Hapeville
georgia

DESIGN REVIEW COMMITTEE

July 17, 2024 6:00 PM

AGENDA

SHEET NO.

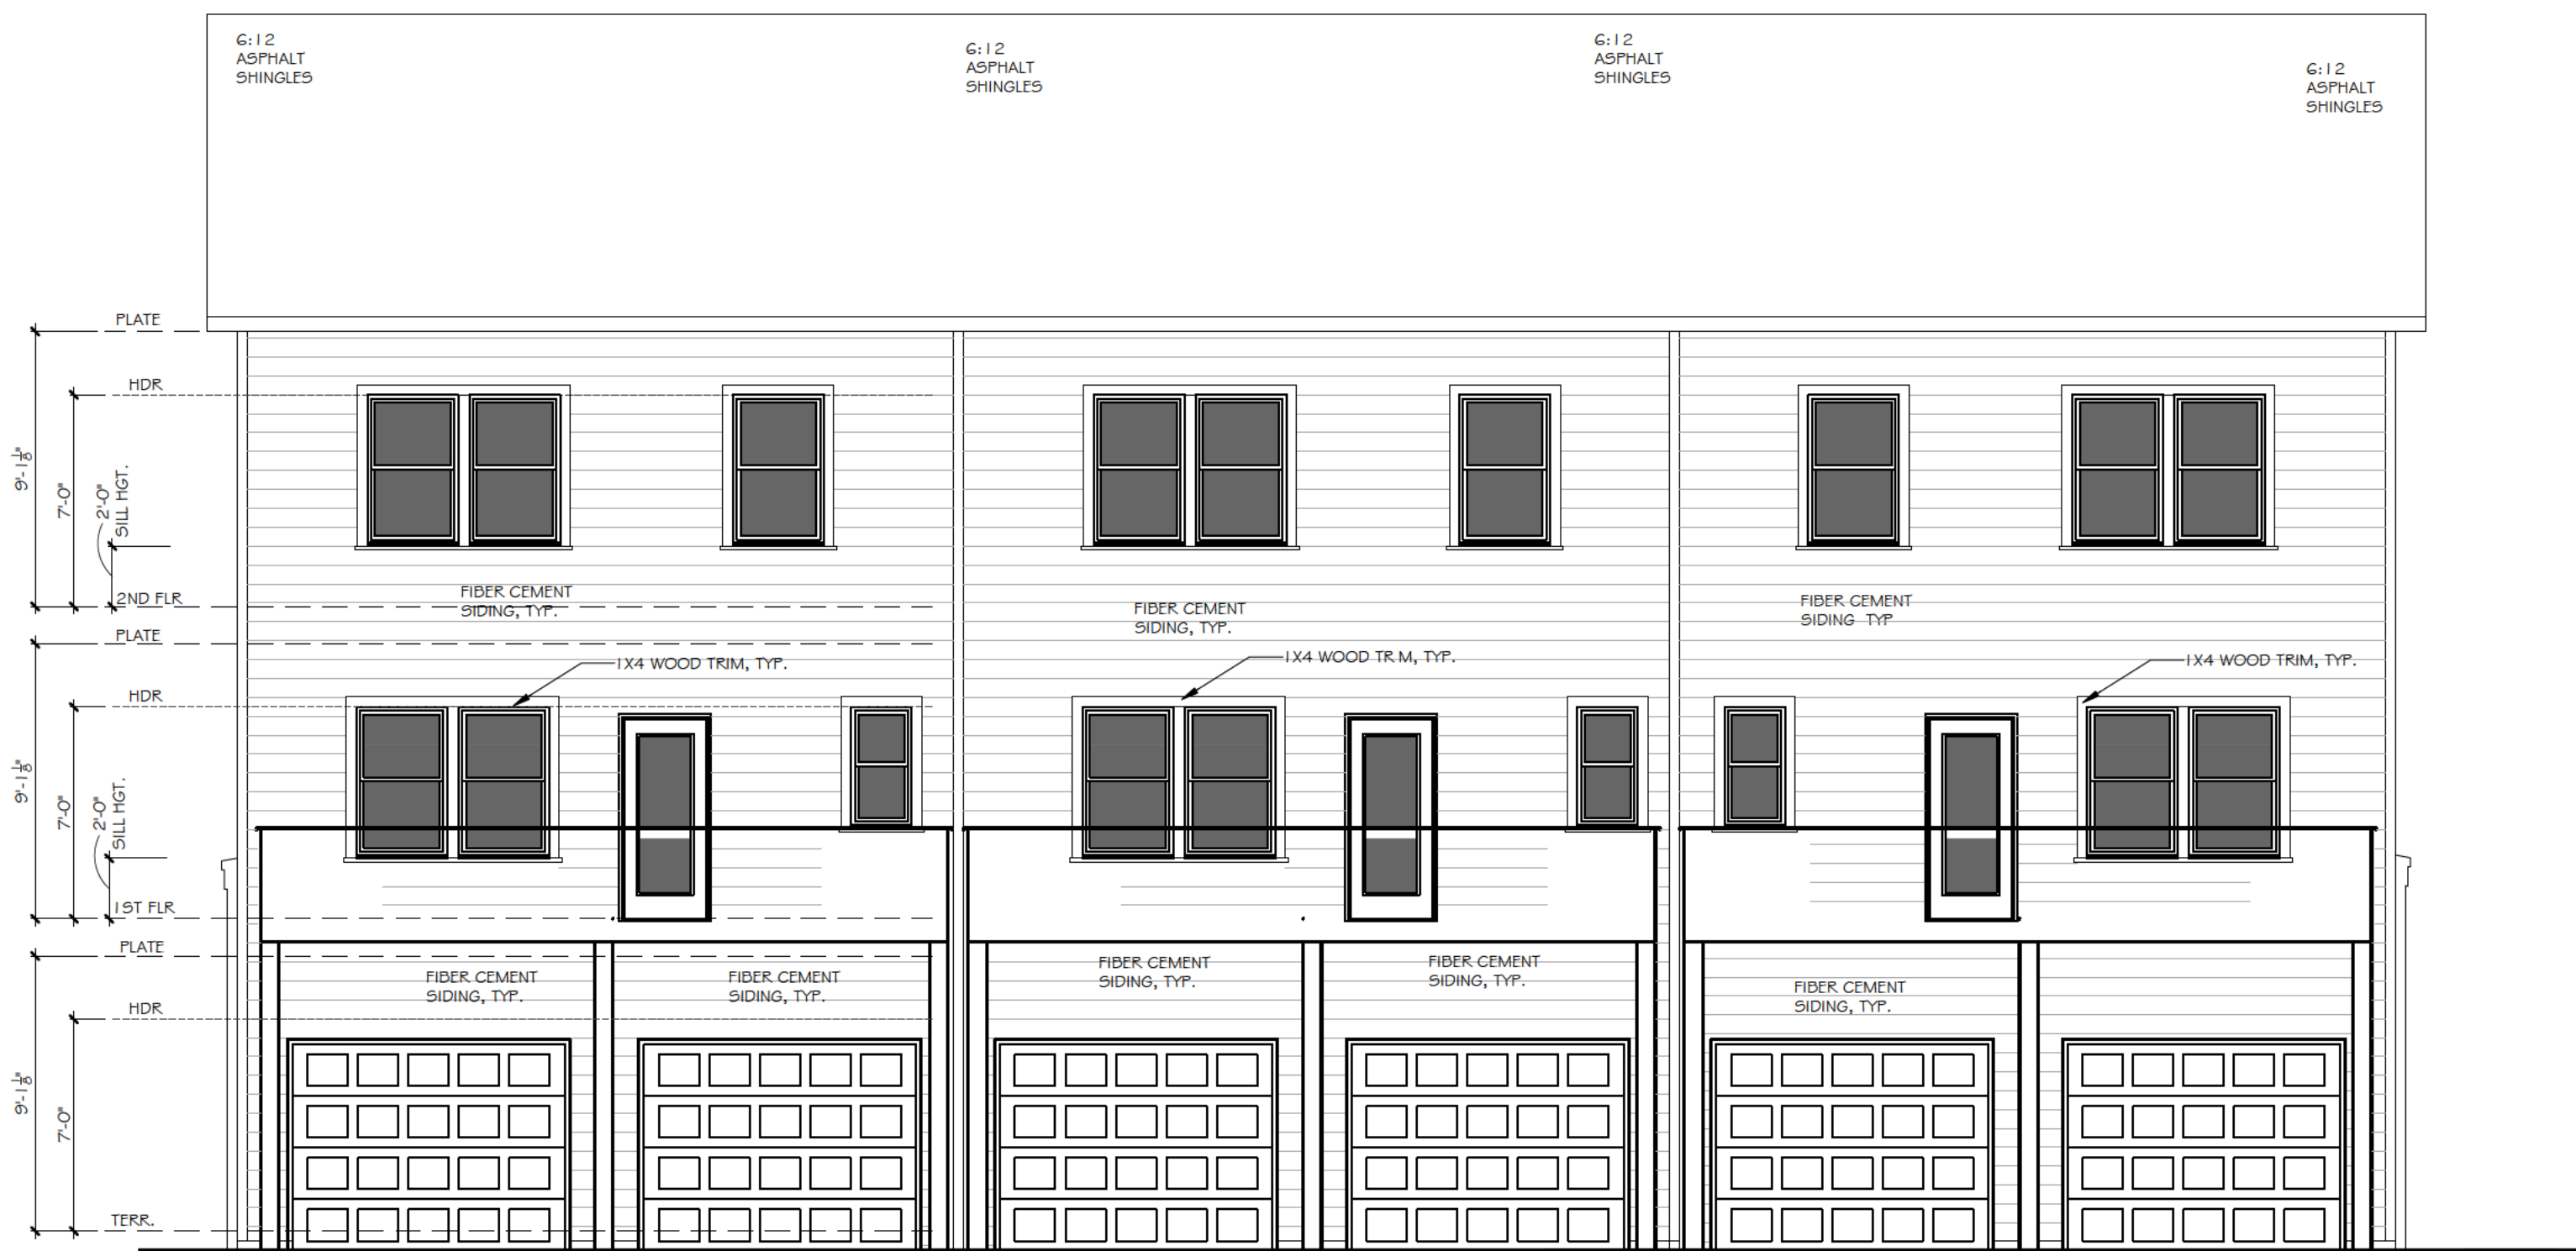
- **Building numbers should be provided.**
Partially addressed. Include unit numbers on each unit.
- Window recess detail should be provided.
Addressed.
- Trim detail should be provided for mullions.
Addressed.

- **Note on plans indicate: ALL ROOF PLAN OVERHANGS TO BE 12" UNLESS NOTED OTHERWISE.**
Overhangs may NOT be less than 12"
- b. Discussion on building height not exceeding 45-ft (zoning requirement). Applicant agrees to define structure heights on plans.
Addressed. Per design standards definitions "Height. A vertical measurement from the average adjacent grade of the ground to the ridge line of a structure." The height shown on the plans from the adjacent grade is 43' 10"

- c. Change bird-box soffits to sloped or Queen Anne style soffits.
Addressed
- d. **Note material of any decking on plans**
Not addressed.
- e. Third Row (units 33-38) wrap brick around corners at water table and in entry door recesses on front facade
Addressed

- f. **Indicate handrails on Third Row units as needed**
Not addressed as grade is not shown.
- g. Add additional windows on left and right elevations as discussed
Addressed

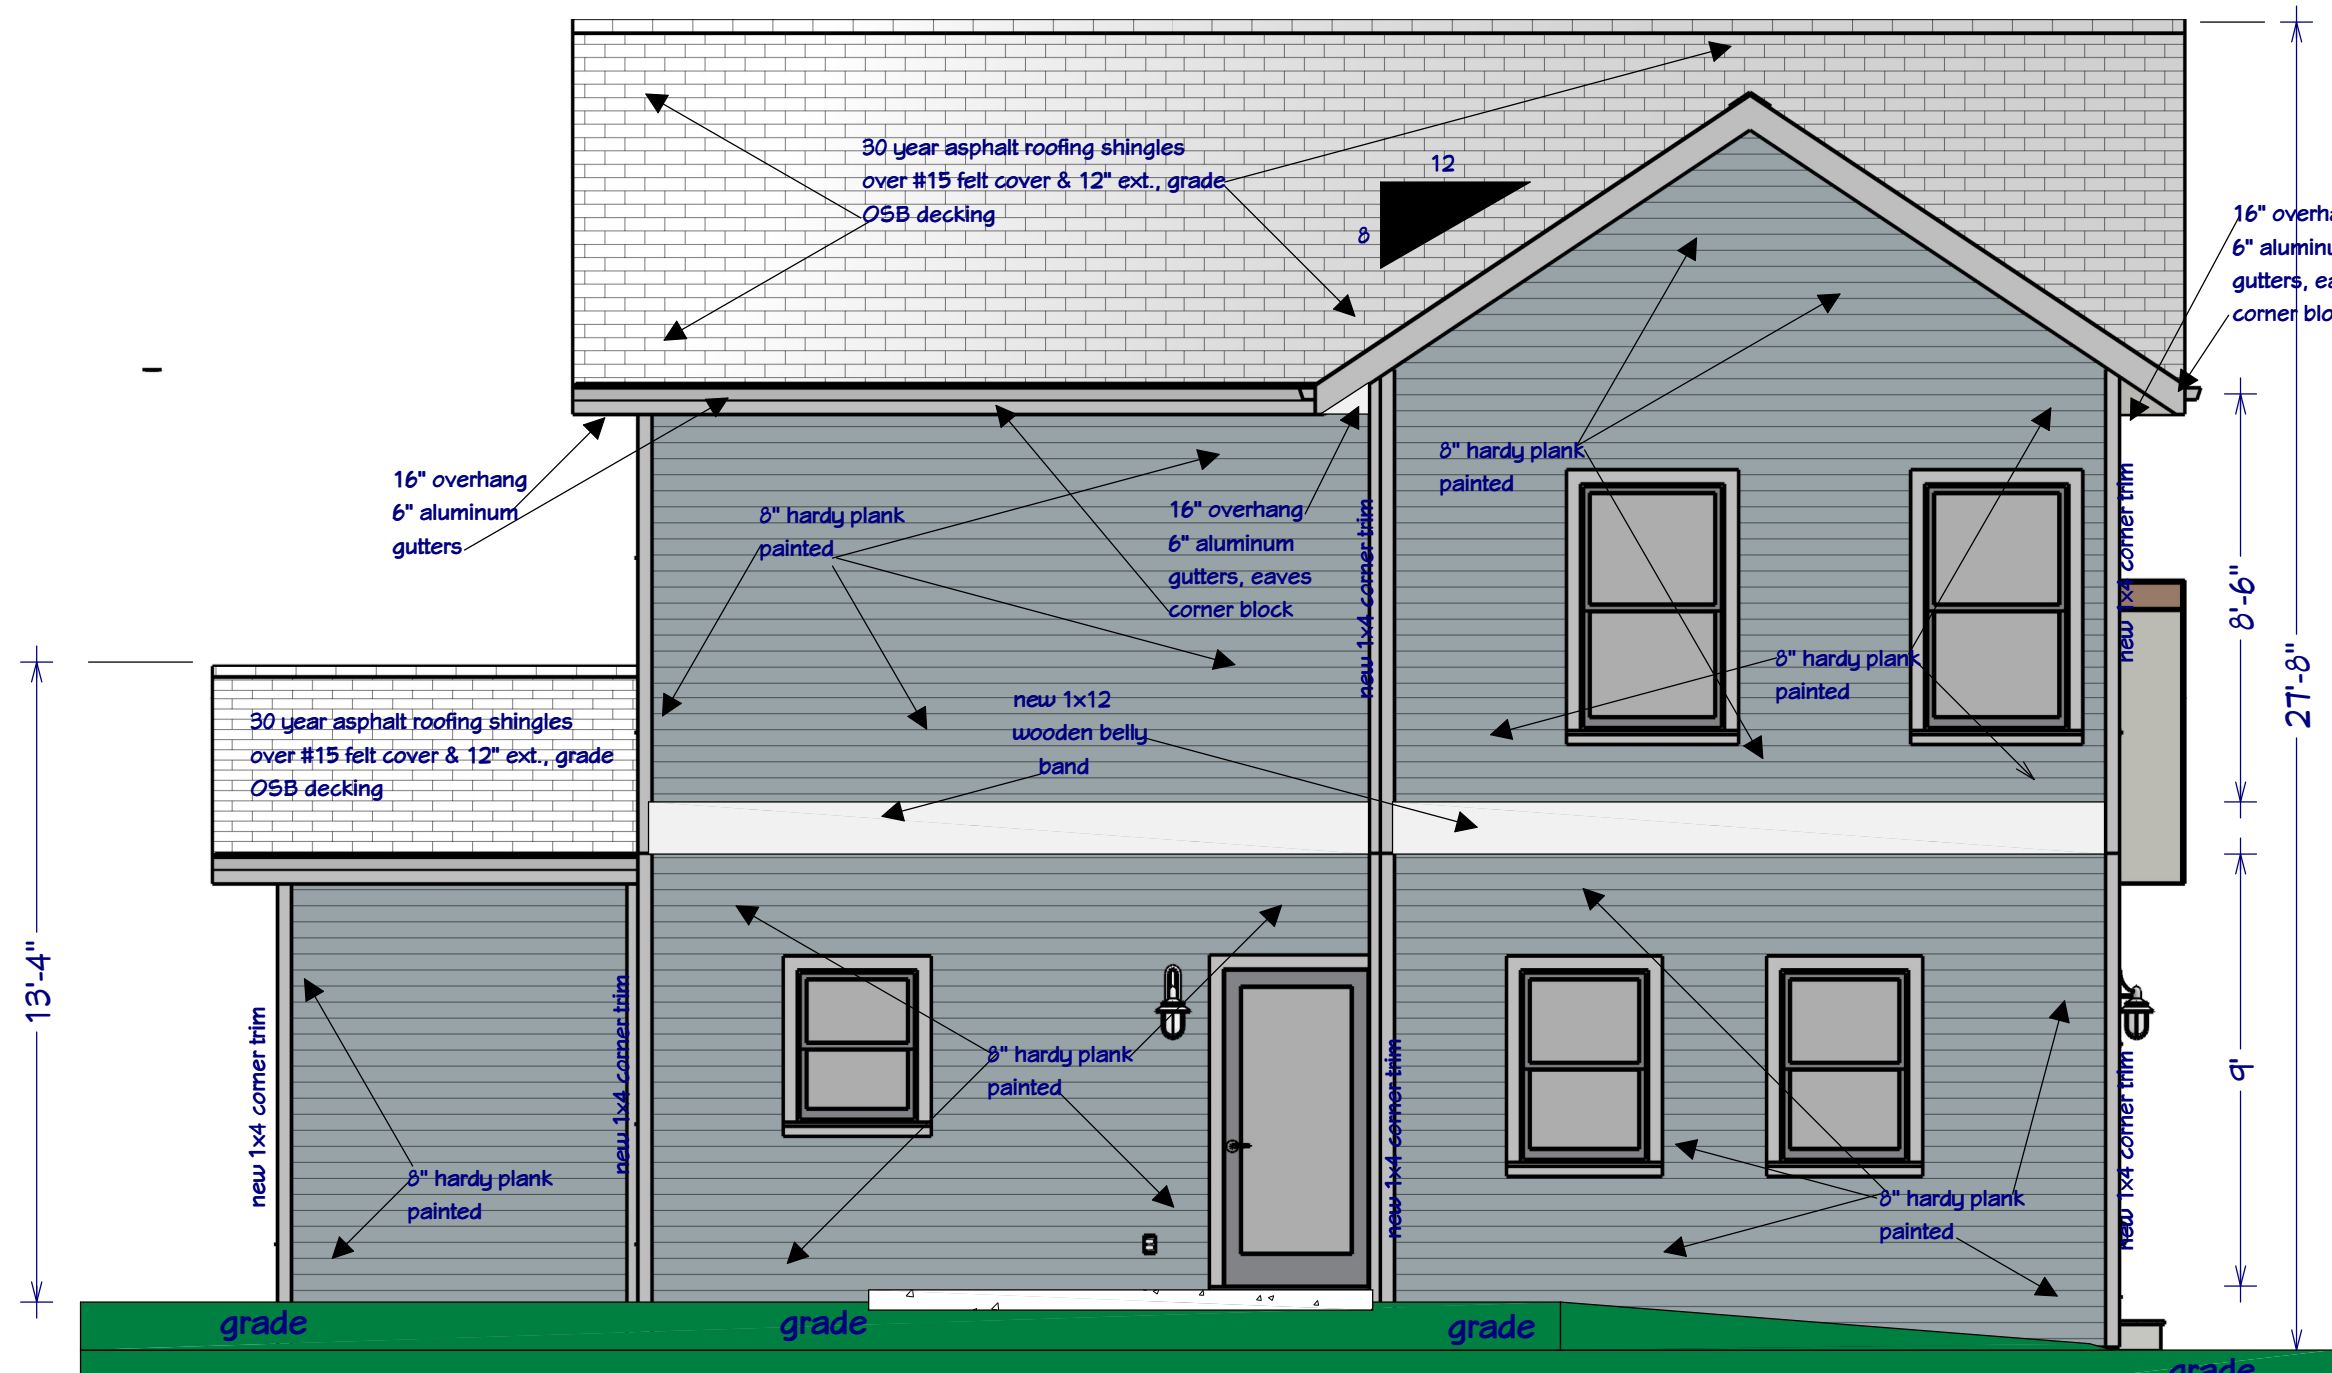
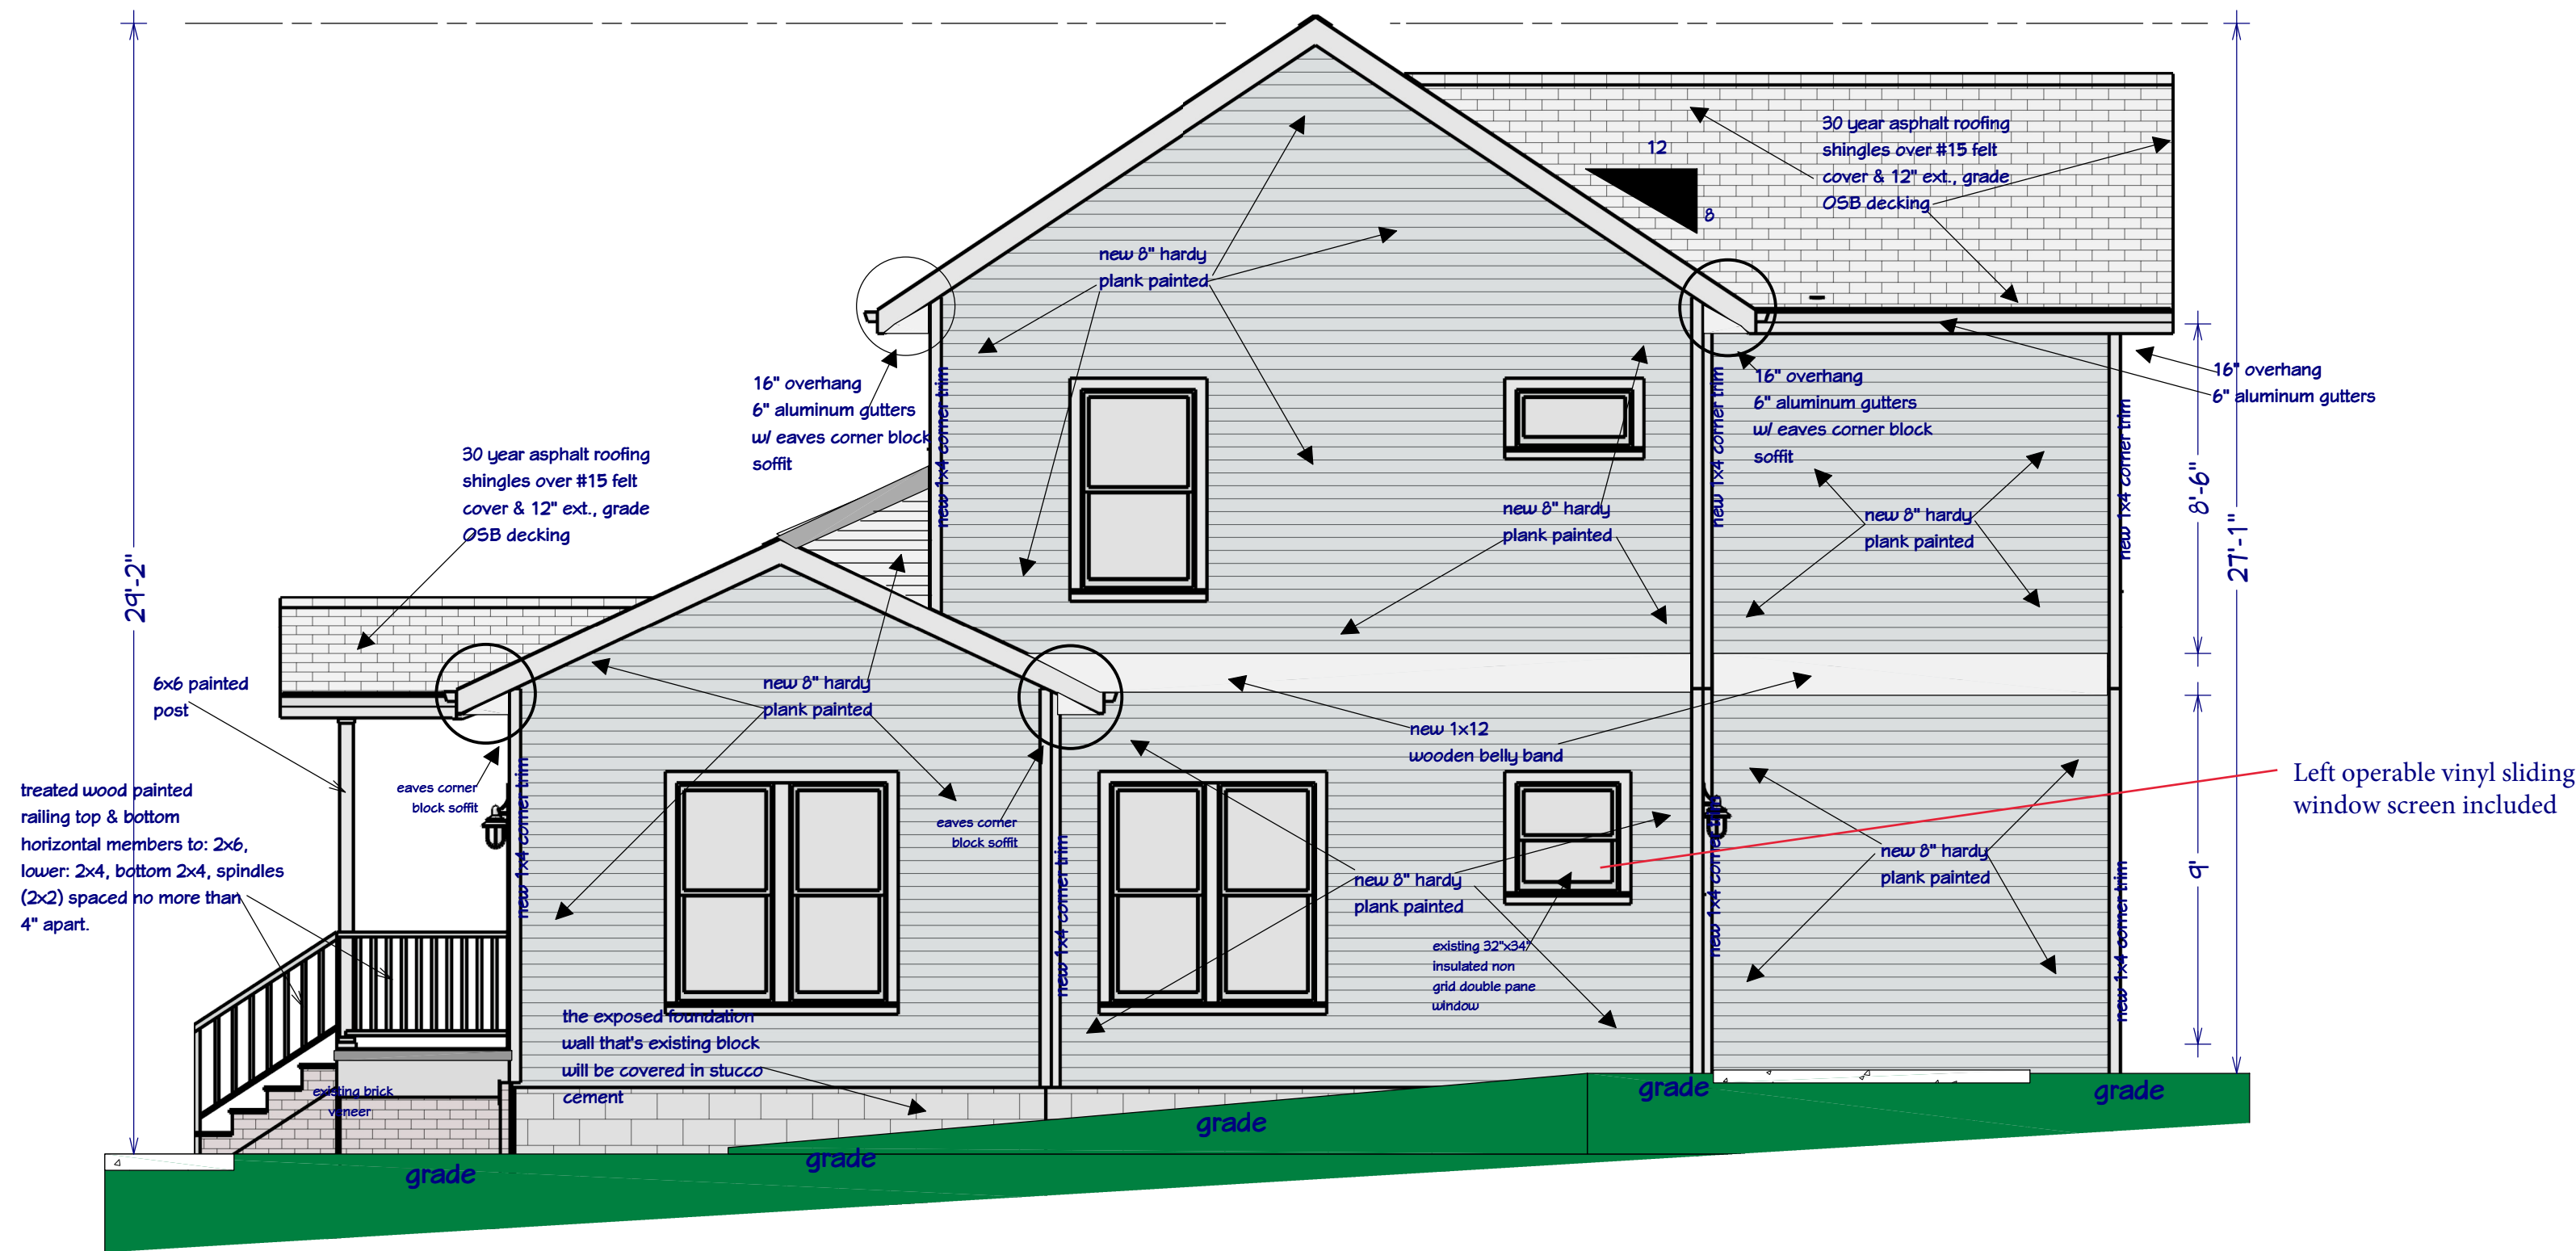
- The slope on the front porch gable is not the same slope as constructed (proposed front elevation). This should be corrected.
- The window sizes on the front second floor plans do not match the new windows as installed (Item #4 in Applicant letter, proposed floor plan-2nd floor). This should be corrected.

- The soffits are now shown with eaves blocks (item #6 of Applicant letter) **instead** of sloped soffits as required from the meeting and as shown and approved from previous submissions (all elevations). The DRC directed the applicant to keep the sloped soffits and correct during construction when application revisions are approved.

- A 12” overhang is still shown on the Proposed Left Side Elevation though a 16” overhang is requested and shown on the other 3 elevations.
- The proposed right-side and left-side elevations still show fixed transom windows, yet the installed windows are described as operational (Item #5 indicated in the letter dated June 10, 2024).

- Item #2 states "We are requesting to trim the windows with 6" x 2" recessed hardy plan on to the sealed structured. Surrounding the window with the approved sized cement hardy plank trim." **Why is this described as recessed?** The trim is to provide the appearance of a recessed window, not trim. It is recommended the DRC see a detail drawing for the proposed trim.

- A 2" sill (wood, hardy-plank or vinyl) has been called out on the proposed front elevation drawings and in Item #3 of the applicant letter. It is recommended that the DRC see the proposed sill material/design detail.
